# HISTORIC AND DESIGN REVIEW COMMISSION

**HDRC CASE NO:** 2025-062  
**ADDRESS:** 3314 N ST MARYS ST  
**LEGAL DESCRIPTION:** ICB 6078 BLK 2 LOT 1&2  
**ZONING:** NC CD, RIO-1  
**CITY COUNCIL DIST.:** 1  
**APPLICANT:** colin bass  
**OWNER:** colin bass/FLYNN DEIRDRE SIOBHAN EST OF  
**TYPE OF WORK:** Parking lot installation  
**APPLICATION RECEIVED:** February 18, 2025  
**60-DAY REVIEW:** May 18, 2025  
**CASE MANAGER:** Edward Hall

## REQUEST:

**SITE PLAN**

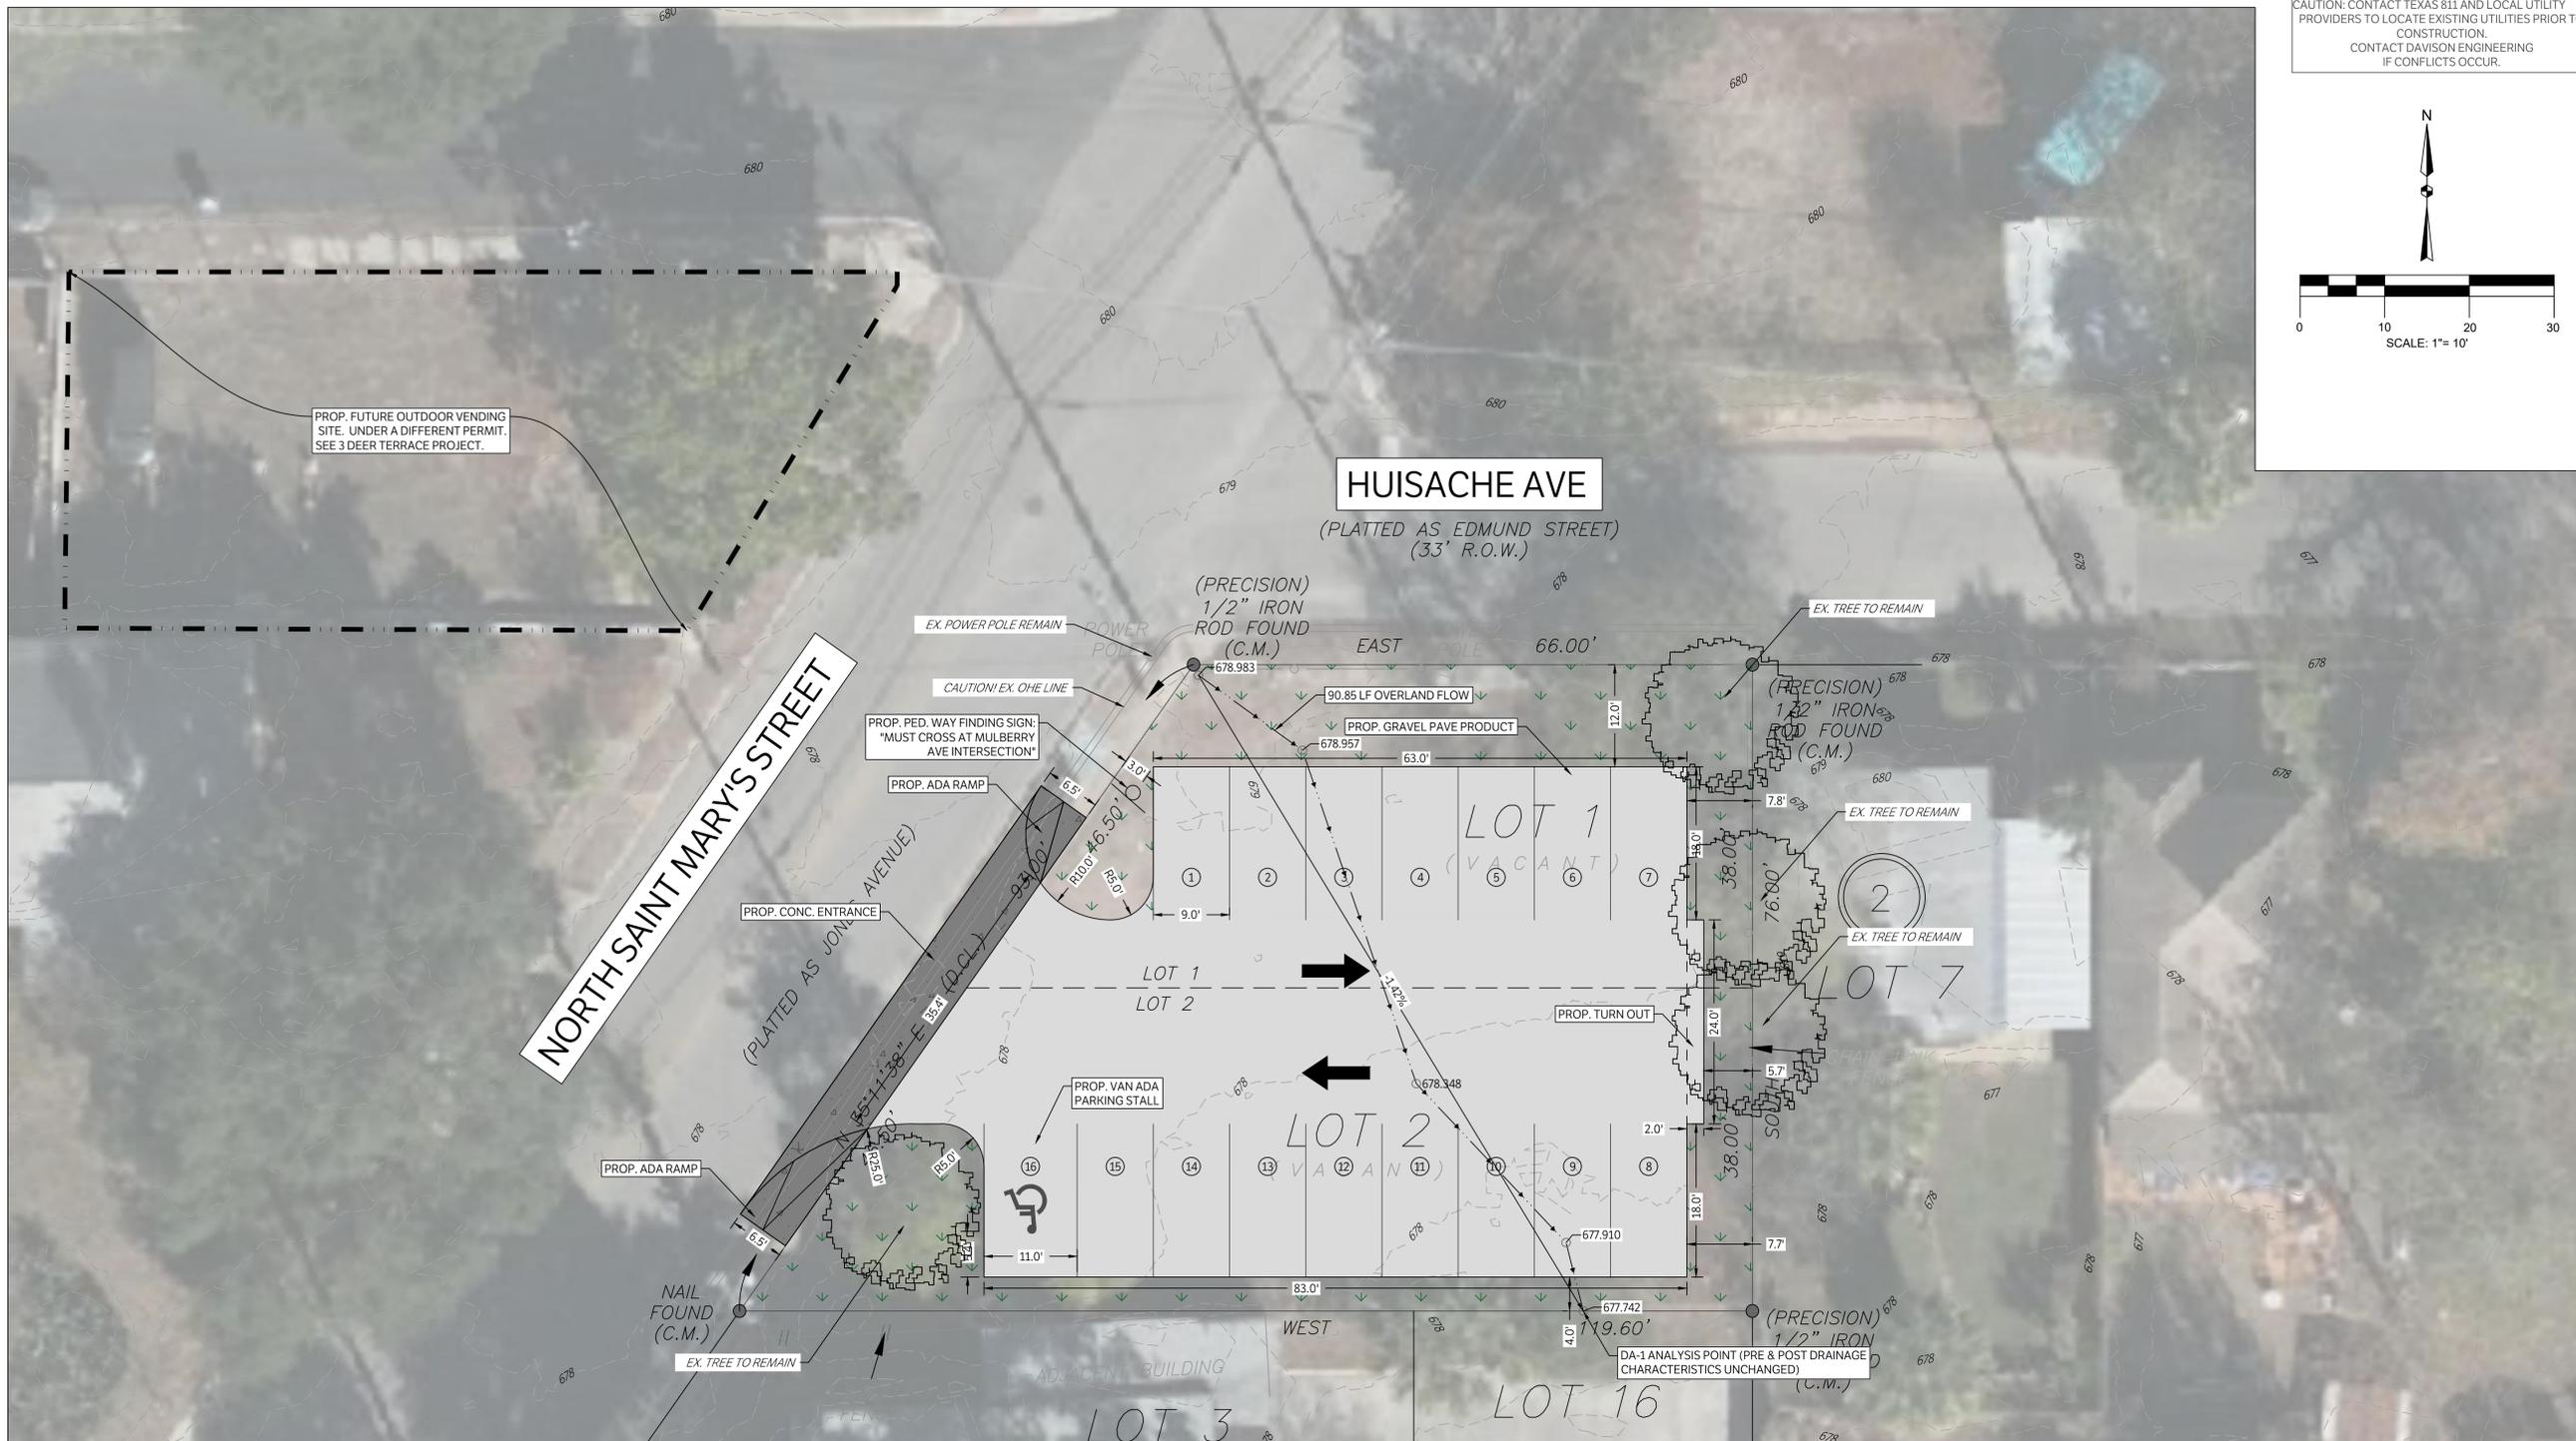
- b. CURB CUT – The applicant has proposed a surface parking lot to feature parking for sixteen (16) automobiles. The proposed parking lot will feature an entrance on N St Mary's, with a curb cut featuring approximately thirty-five (35) feet in width. The UDC Section 35-672(b)(1)(B) states that curb cuts should not exceed twenty-five (25) feet in width. Staff finds that the proposed curb cut should be reduced to be consistent with the UDC.

- d. BUFFERING – The applicant has proposed landscape buffering from both N St Mary's and Huisache Avenue. The UDC Section 35-672(b)(3) provides requirements for buffering per table 510-2. Per table 510-2, a type B bufferyard is required, which requires the following elements: a minimum width of fifteen (15) feet, two (2) canopy trees, two (2) understory trees, eight (8) large shrubs and eight (8) medium shrubs.

- i. That the proposed curb cut be reduced to no more than twenty-five (25) feet in width, as noted in finding b.
- ii. That the applicant introduce a buffer yard as required by the UDC Section 35-672(b)(3) and the UDC Table 510-2, to include the following: a minimum width of fifteen (15) feet, two (2) canopy trees, two (2) understory trees, eight (8) large shrubs and eight (8) medium shrubs.
- iii. That any future lighting elements be submitted to the Office of Historic Preservation for review and approval.
- iv. ARCHAEOLOGY – The project shall comply with all federal, state, and local laws, rules, and regulations regarding archaeology, as applicable.
